SUPPLEMENTAL GEOTECHNICAL INVESTIGATION

PROPOSED TAILING DAM NO. 2

FEDERAL-AMERICAN PARTNERS

7.0 NRC QUESTIONS AND RESPONSES

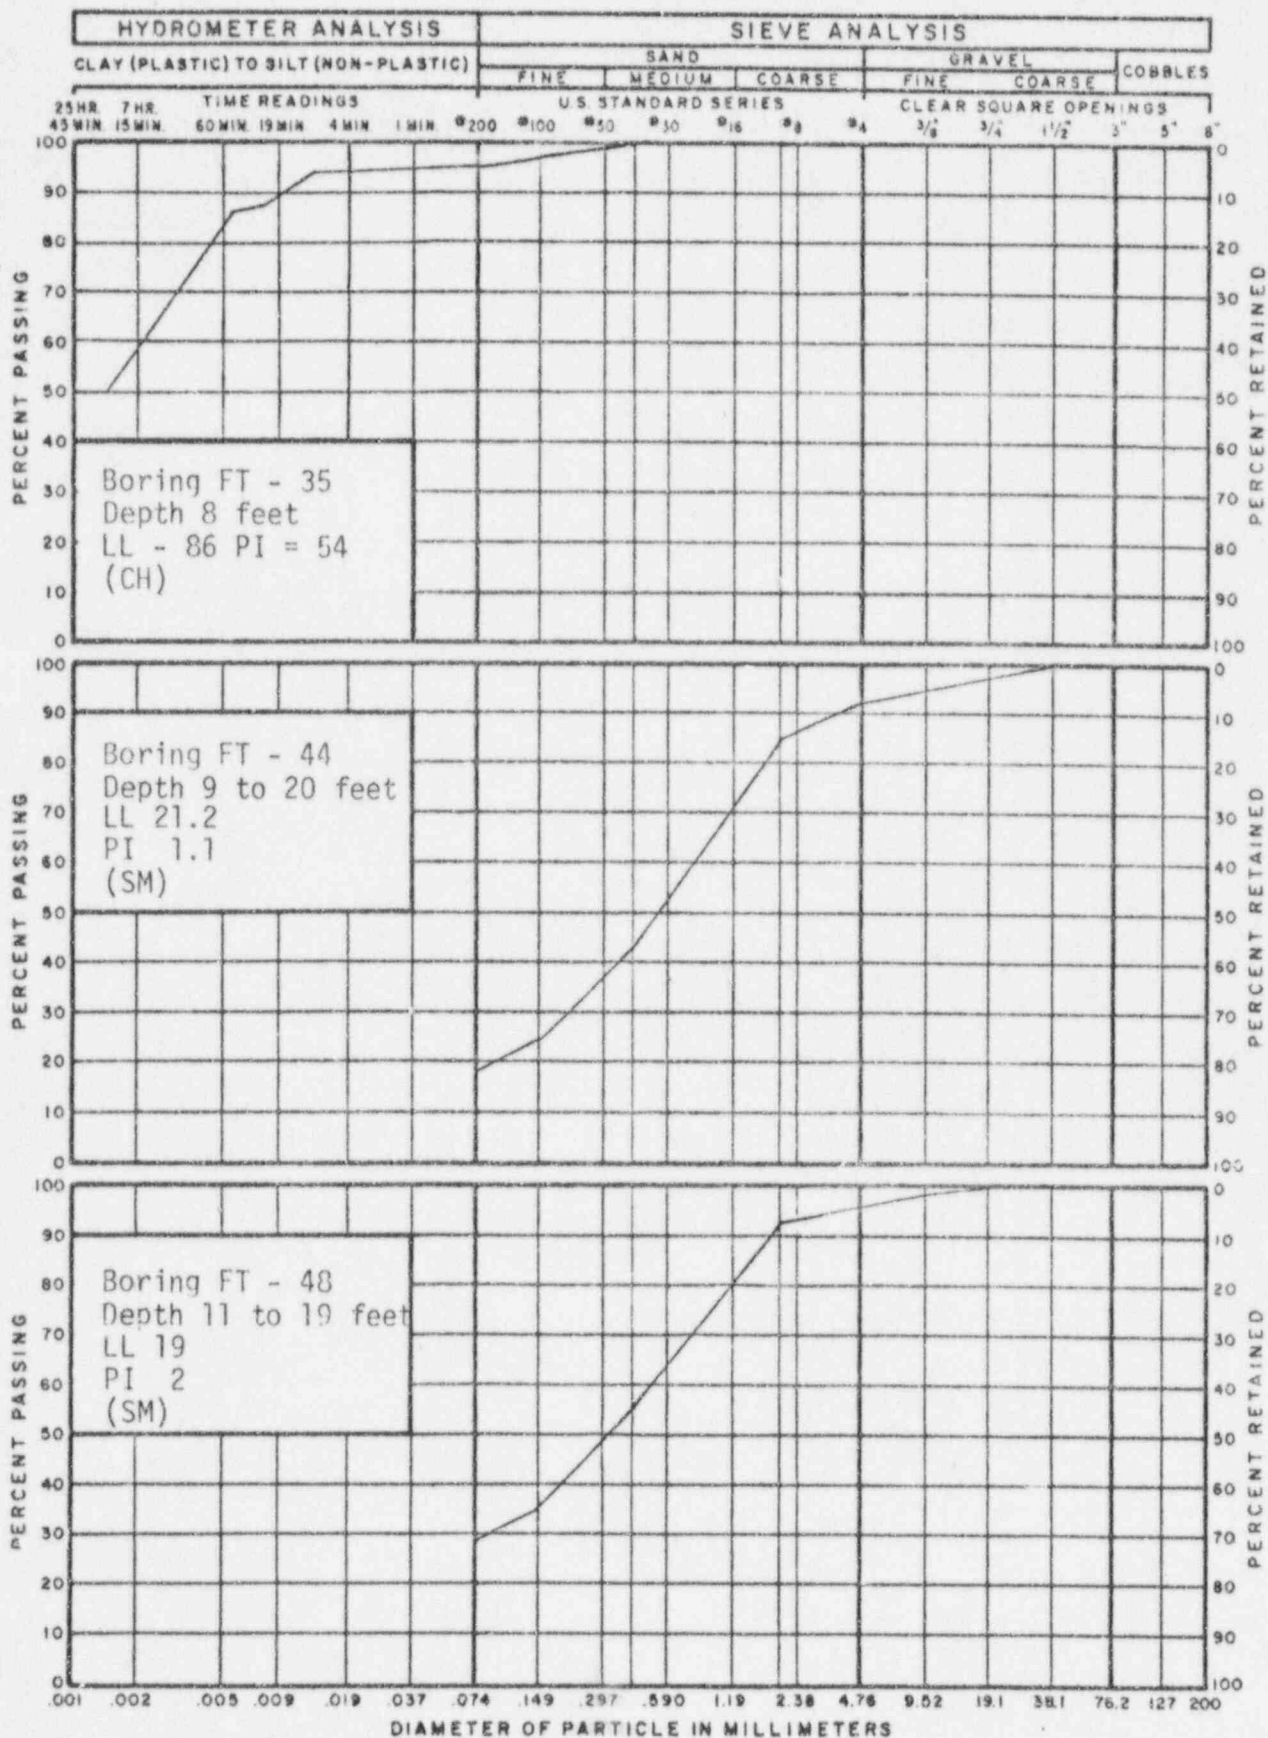
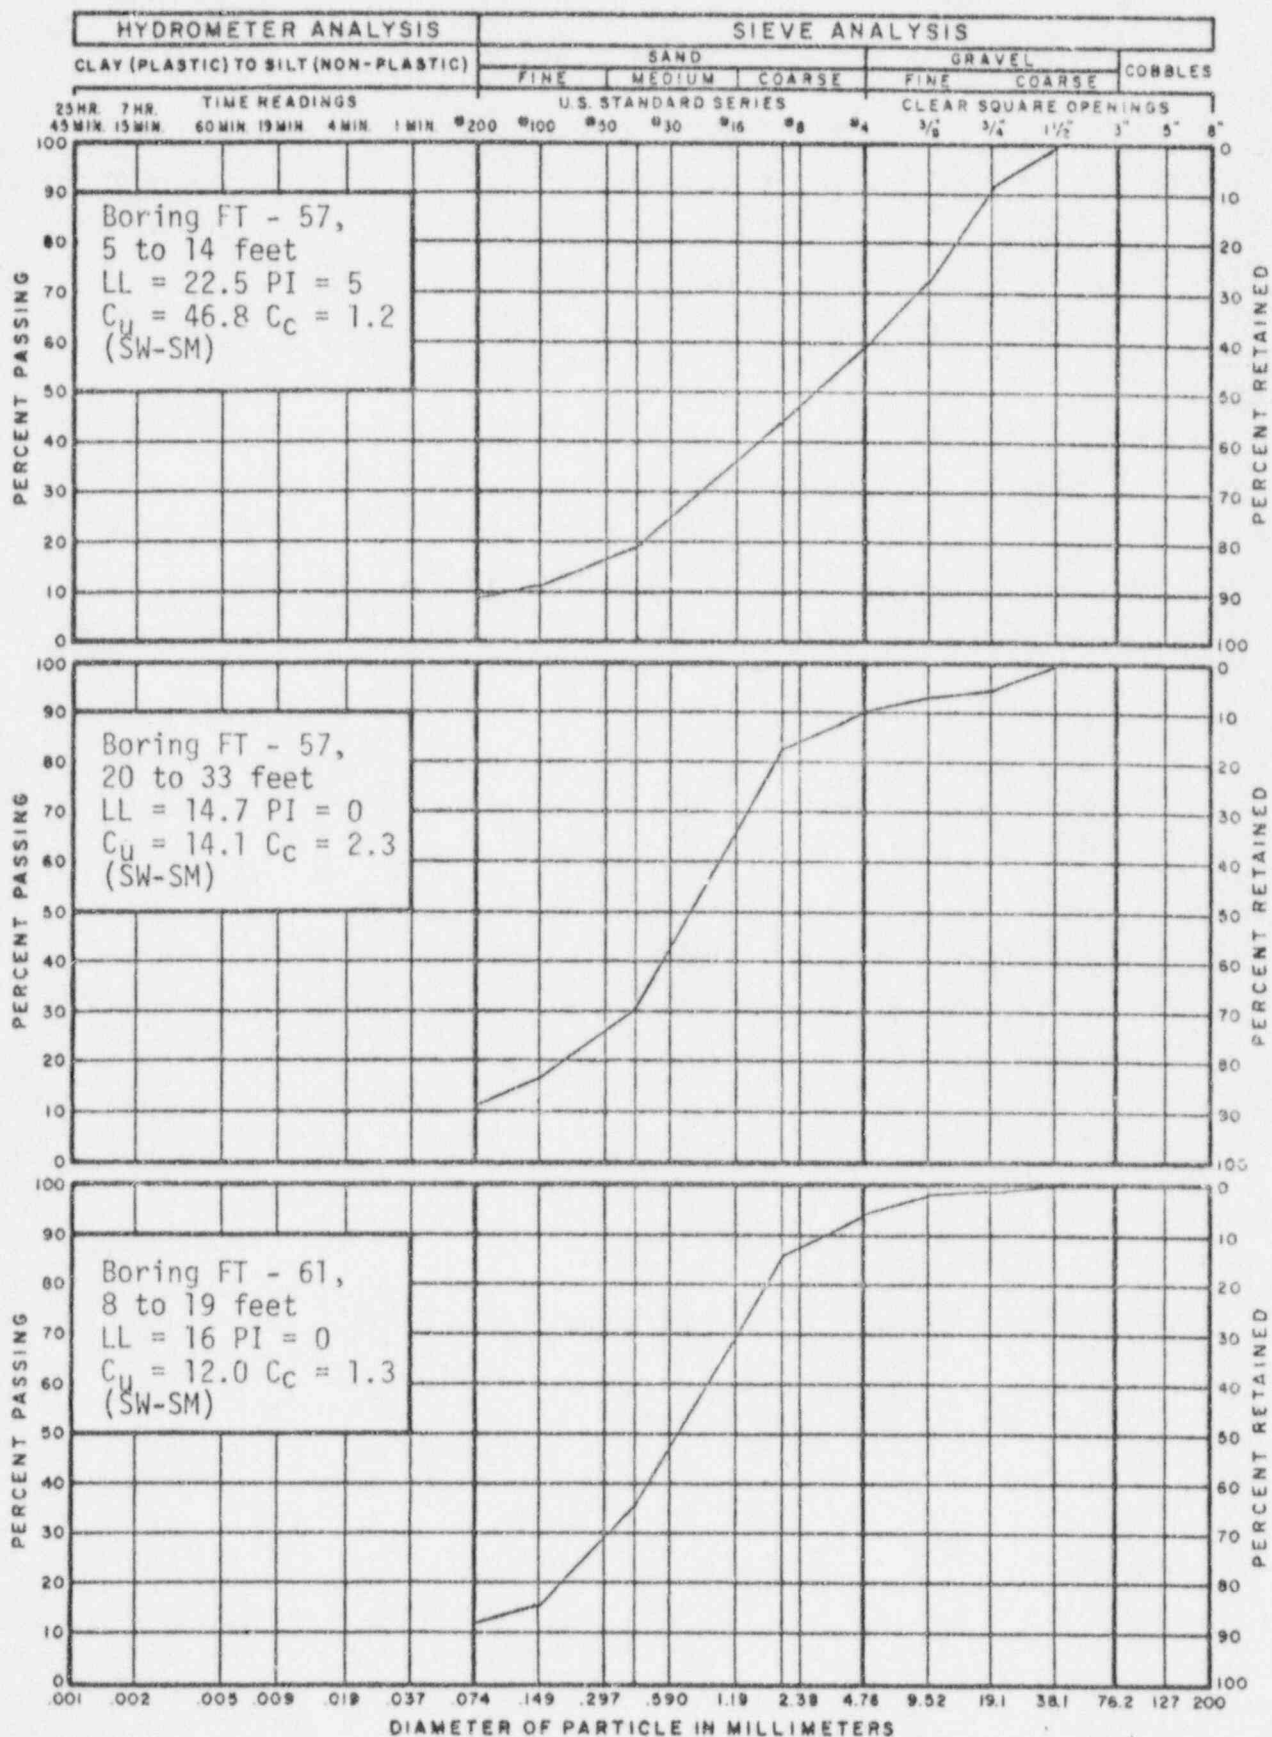
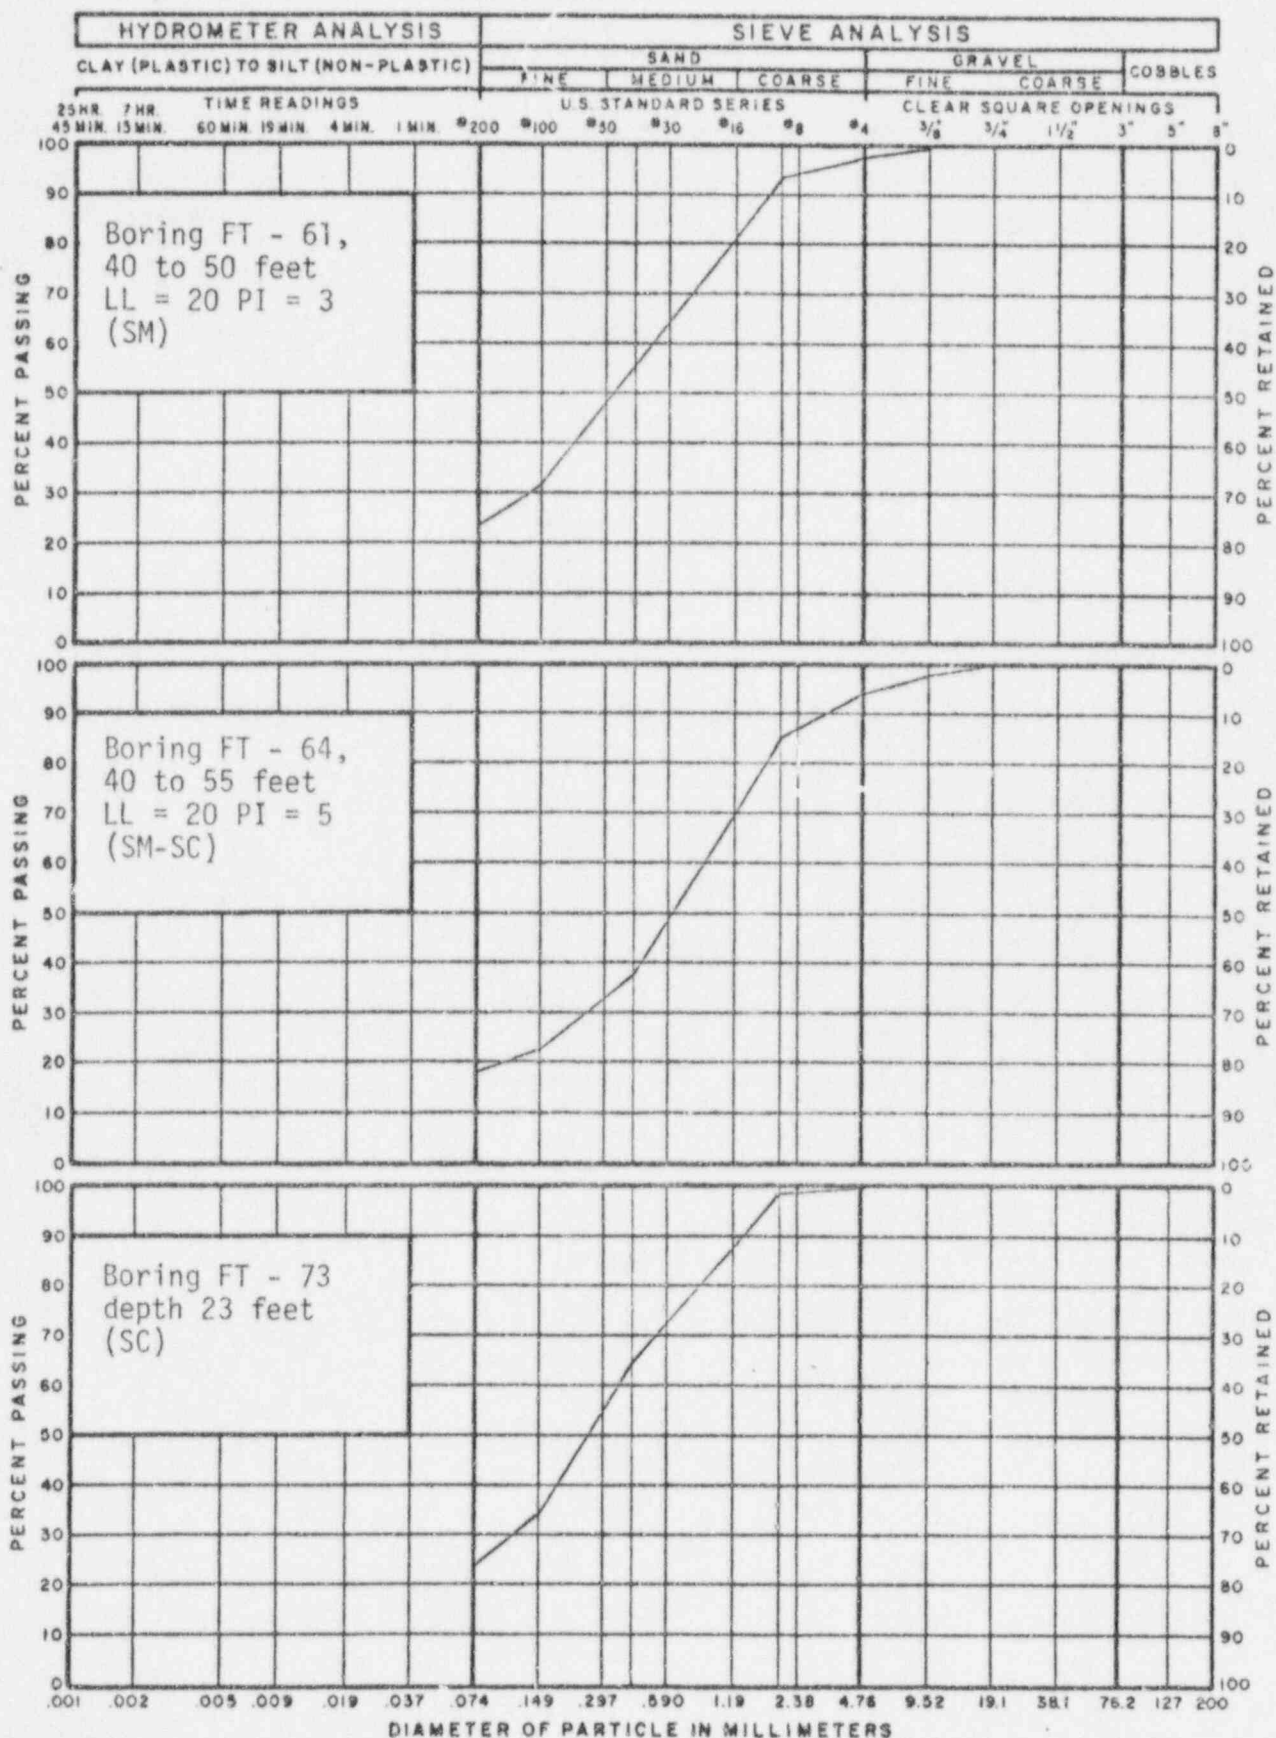
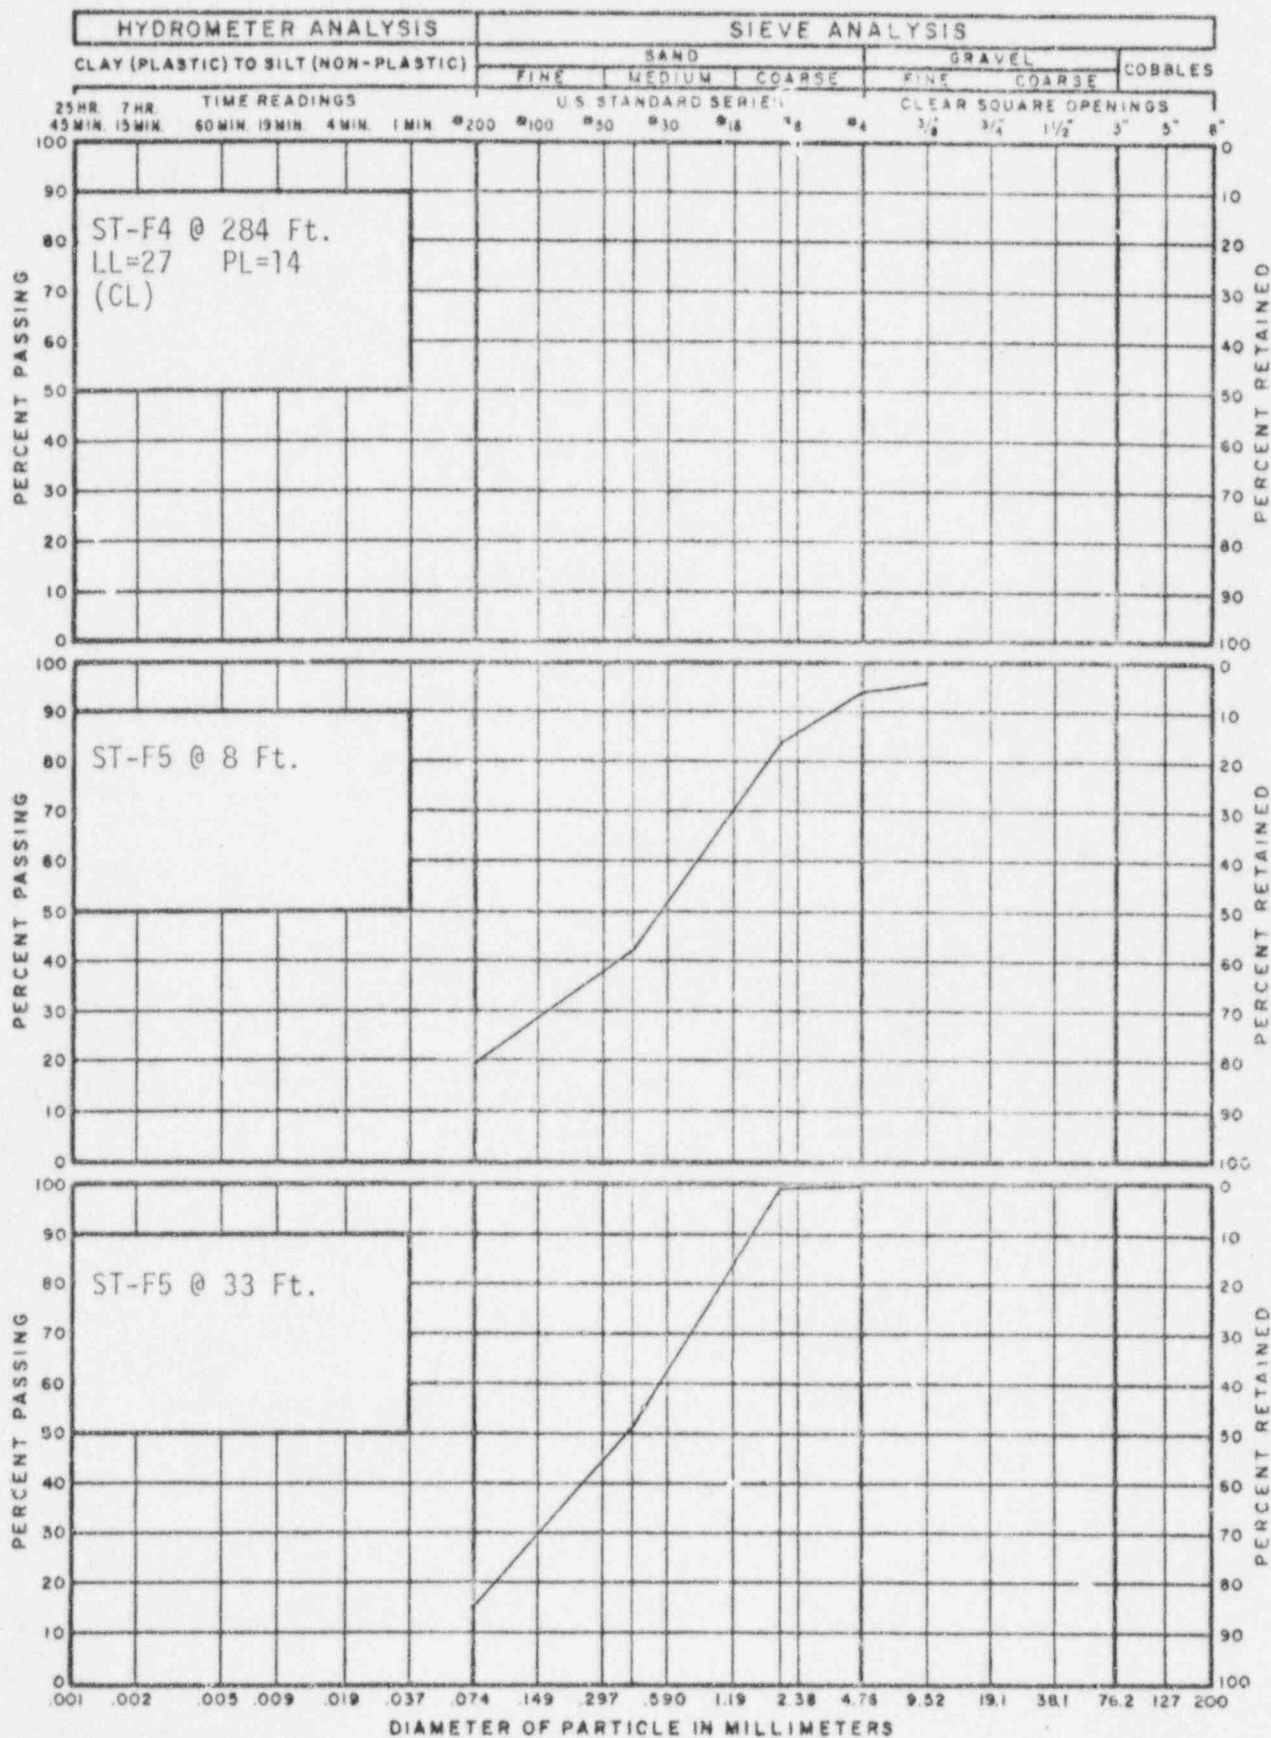
Provide details of the proposed borrow materials to be used for embankment construction. Include:

- a. A location plan showing areal extent of borrow area.
- b. Justification that adequate quantity of suitable material is available for embankment construction.
- c. The results of subsurface exploration of the borrow area. Include test boring and test pit logs.
- d. The results of laboratory tests on representative samples showing the soil properties and strength parameters for compacted fill materials as they will be used in embankment construction. Include identification tests, compaction and/or maximum-minimum density tests, permeability tests or estimates, strength tests.
- e. A comparison of the laboratory test results with the values assumed in design stability analyses. Provide revised stability analyses if the laboratory values are not compatible with the design criteria.

The original borrow material was to be removed from the western half of Impoundment No. 2, refer to Section 9.3 of our report Geotechnical Investigations for the Proposed Extensions of Tailing Dams No. 1 and 2, Job No. 1-1371-3454. The proposed borrow area is now designated as the Sagebrush-Tablestakes Pit. As we discussed in our meeting with the NRC, it would be sufficient to show that the now proposed borrow has similar mechanical

properties as that of the original borrow. In comparing the original borrow area material with that from the Sagebrush-Tablestakes extension area, both materials were found to be similar and suitable for use as embankment material. Refer to the enclosed sieve analysis, Figures B1-7 through B1-9 from our original report Geotechnical Investigation for the Proposed Extensions of Tailing Dams No. 1 and 2, Job No. 1-1371-3454, and Figures D-4 through D-7 along with our lithological logs A-3 through A-5 from our report Geotechnical Investigation and Design for the Subsurface Disposal of Millwaste, Job No. 1-1371-3771.

The estimated required volume of suitable borrow material for Tailing Dam No. 2 extension is approximately 1 million cubic yards. The available volume of suitable borrow material from the Sagebrush Tablestakes Pit exceeds this requirement, (i.e., the total volume of the pit is in excess of 12 million yards). Refer to Plate 1 of this report from our Geotechnical Investigation and Design of the Subsurface Disposal of Millwaste, Job No. 1-1371-3771, for existing and proposed Sagebrush Tablestakes pit limits.
